Well Name: BEARS FEDERAL	Well Location: T16S / R29E / SEC 6 / LOT 8 / 32.9591919 / -104.108142	County or Parish/State: EDDY / NM
Well Number: 2	Type of Well: OIL WELL	Allottee or Tribe Name:
Lease Number: NMNM98171	Unit or CA Name:	Unit or CA Number:
US Well Number: 300153576900S1	Well Status: Oil Well Shut In	Operator: MACK ENERGY CORPORATION

Notice of Intent

Type of Submission: Notice of Intent	Type of Action: Plug and Abandonment
Date Sundry Submitted: 12/21/2023	Time Sundry Submitted: 11:34
Date proposed operation will begin: 01/06/2024

## Plug Abandonment NOI Proposed

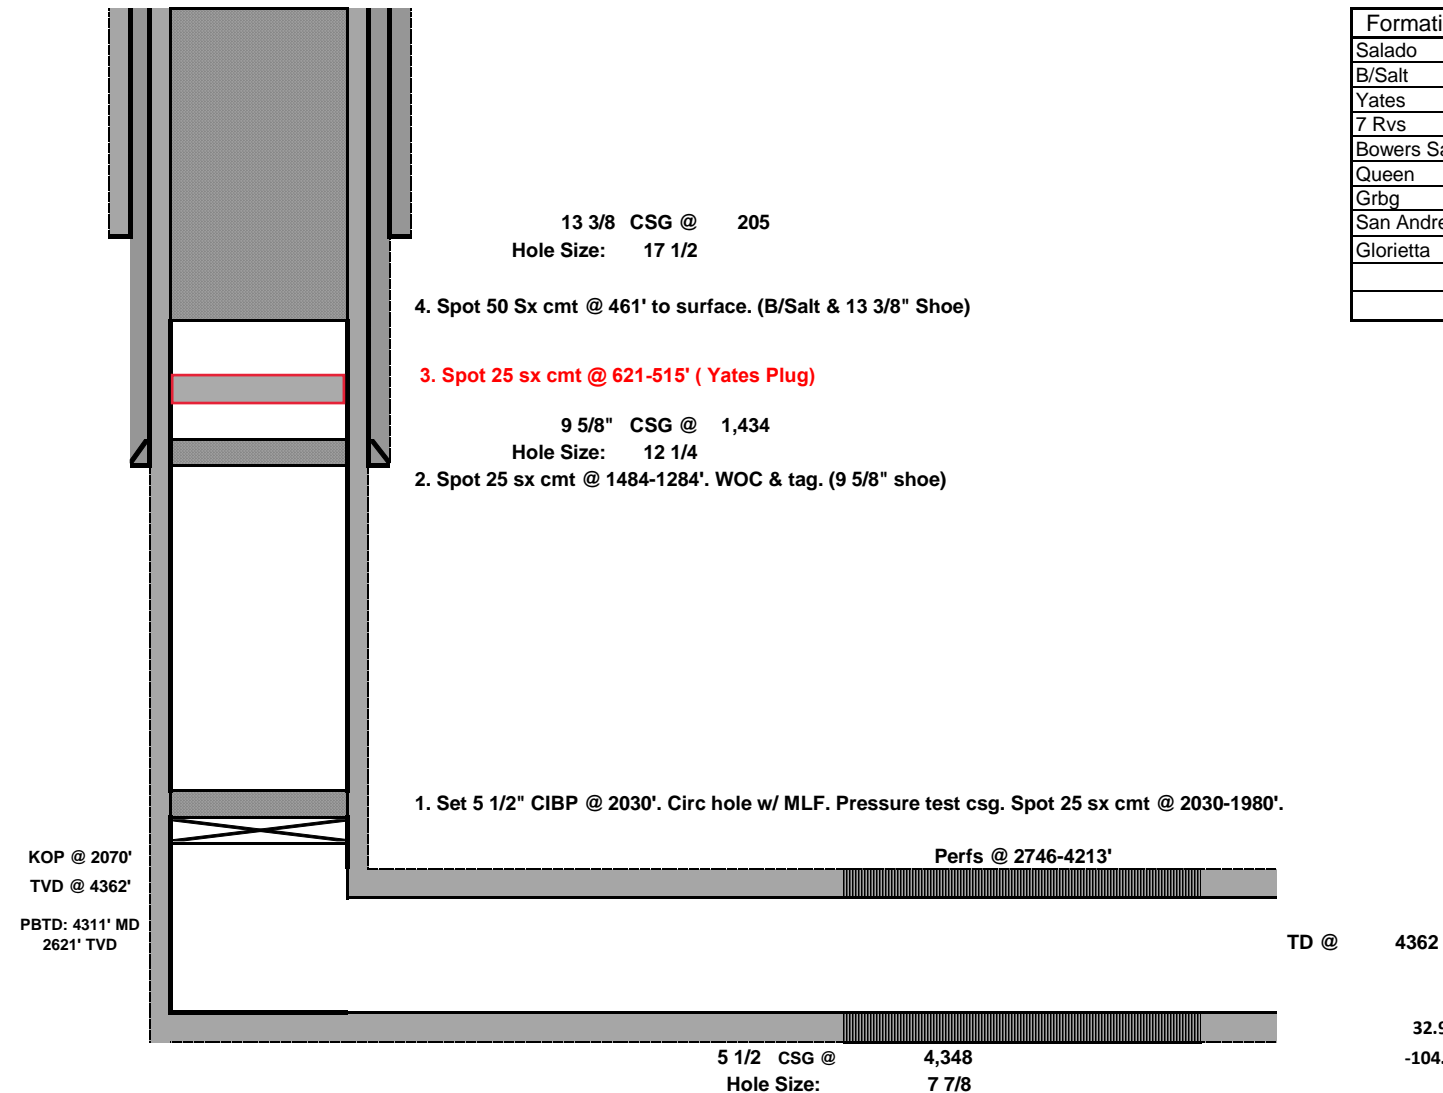
1. Set 5 1/2" CIBP @ 2030'. Circ hole w/ MLF. Pressure test csg. Spot 25 sx cmt @ 2030-1980'.
2. Spot 25 sx cmt @ 1484-1284'. WOC & tag. (9 5/8" shoe)
3. **Spot 25 sx cmt @ 621-515'. WOC & tag. ( Yates Plug)**
4. Spot 50 sx cmt @ 461' to surface. (B/Salt & 13 3/8" Shoe)
5. Cut off wellhead, verify cmt @ surface. Weld on Dry Hole Marker.

Sundry ID		2767141					
Plug Type	Top	Bottom	Length	Tag	Sacks	Cement Class	Notes
Surface Plug	0.00	100.00	100.00	Verify circulated to surface	50 sxs	Class C	
Top of Salt @ 242	0.00	461.00	461.00				
Base of Salt @ 411	0.00	461.00	461.00				
13.375 inch- Shoe Plug	0.00	461.00	461.00				
Yates @ 571	515.29	621.00	105.71	WOC and Tag	25 sxs	Class C	
8.625 inch- Shoe Plug	1284.00	1484.00	200.00	Tag/Verify			
CIBP Plug	1995.00	2030.00	35.00	WOC and Tag	25 sxs	Class C	500psi 30min leak test
				If solid base no need to Tag (CIBP present and/or Mechanical Integrity Test), If Perf & Sqz then Tag, Leak Test all CIBP if no Open Perforations			
Glorieta @ 3554	3468.46	3604.00	135.54	Perforations			
5.5 inch- Shoe Plug	4254.52	4398.00	143.48	Tag/Verify

Created By	Condition	Condition Date
gcordero	A CBL must be run and submitted to OCD via OCD Permitting. Spot 15 sacks cement 1640' - 1540' - T - Grayburg.	3/14/2024
